SERVICE BULLETIN

COLLINS RADIO COMPANY

EQUIPMENT TYPE: KWM-2, KWM-2A TRANSCEIVER

SUBJECT: ADD VOX RELAY TIME CONSTANT CONTROL.

Part C Revised Circuitry

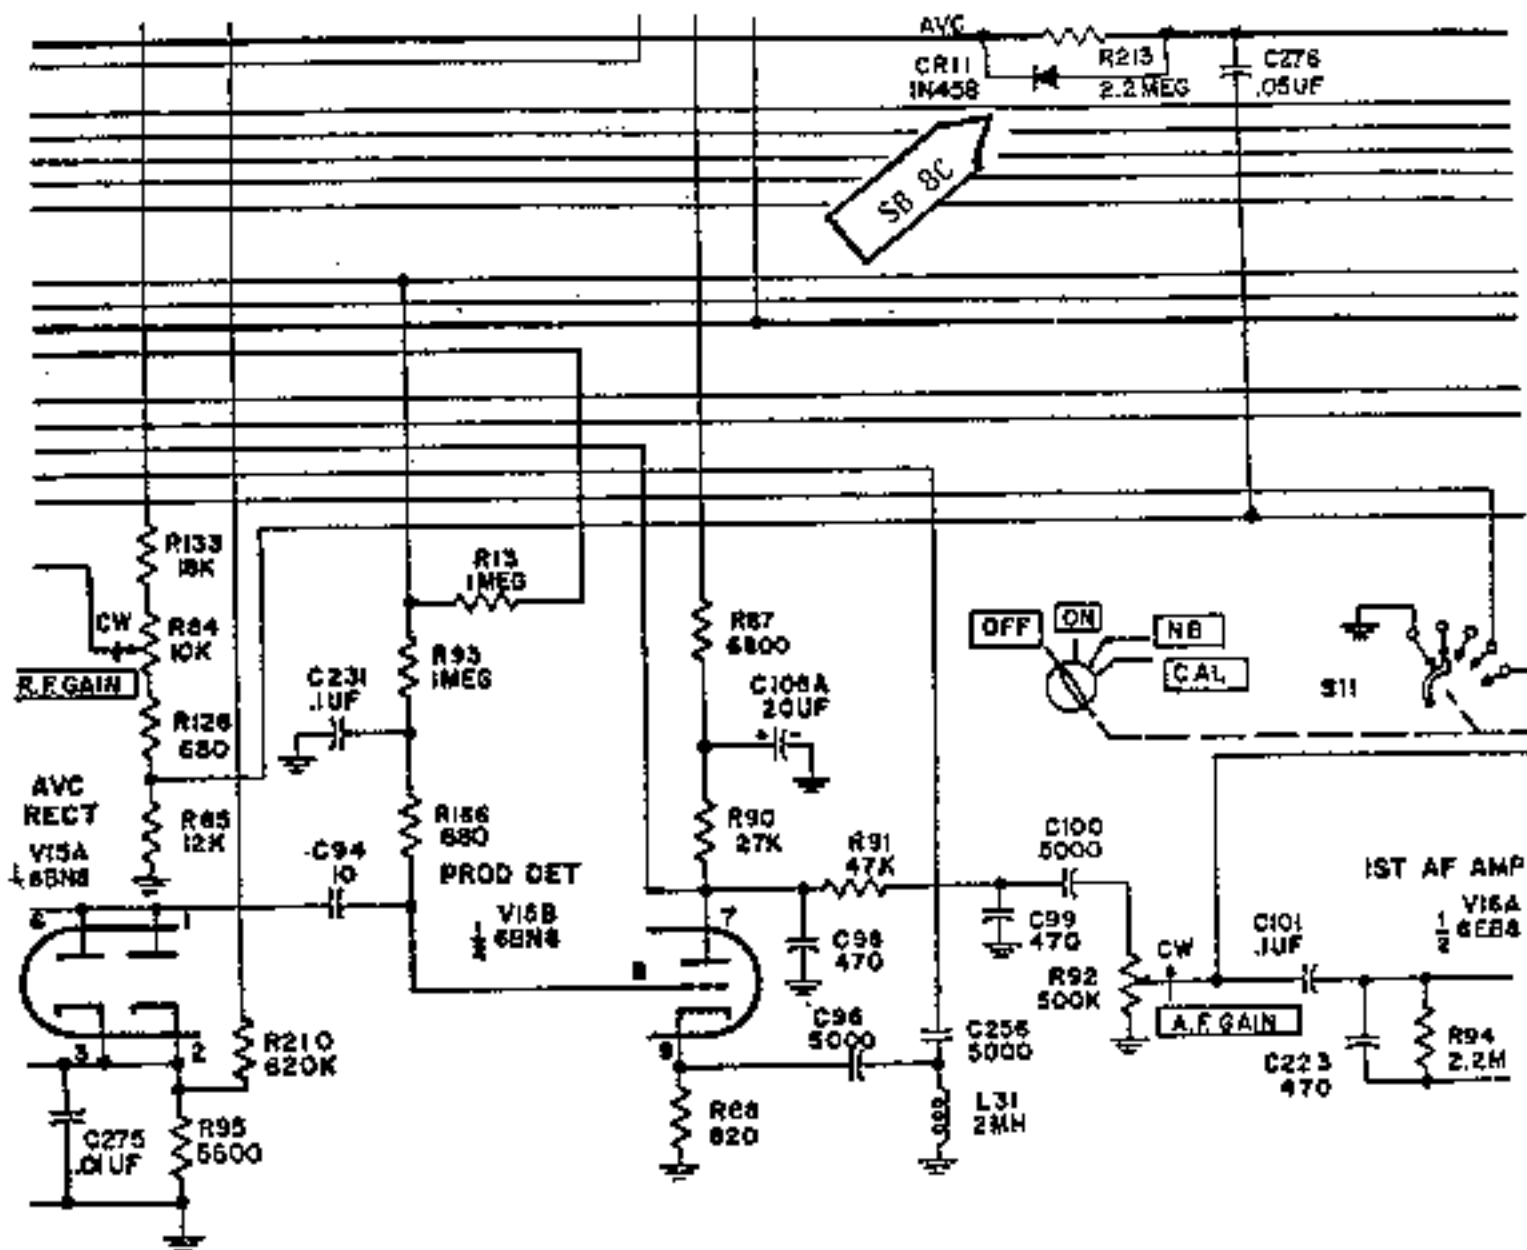
- (a) Perform step (a) of Part A.
- (b) Remove and save the screw and lockwasher, nearer the front panel, used to mount audio output transformer T6.
NOTE: Production units that contain this modification use a 3-terminal strip for T58 in place of adding TS11.
- (c) Install TS-11 (306-0299-000) using the screw and lockwasher removed in step (b).
- (d) Disconnect the white-green-blue wire from TS8-1, pull it back through the cabling and reconnect it to TS11-1.
- (e) Connect R213, 2.2-M Ω 1/2-watt resistor (745-0639-000), from TS8-1 to TS11-1. Sleeve resistor leads with (152-2513-000) as necessary.

- (f) Connect CR11, 1N458 diode, from TSS-1 (cathode/banded end) to TS11-1 (anode end). Sleeve diode leads with (152-2513-000) as necessary.
- (g) Connect C276, .05- μ F capacitor, from TS11-1 to E30-B.
- (h) Of the two white-green-blue wires connected to E40-I, disconnect, tape, and tie back the one showing continuity to the wire on TS11-1.
- (i) Connect a white-green-blue wire (439-4020-000) from E40-I to TS8-1, routing it through the cabling.
- (j) Replace all hardware by reversing step (a).
- (k) Mark information chart (280-3778-010) SB 8C. Apply chart to convenient location on unit if applicable.
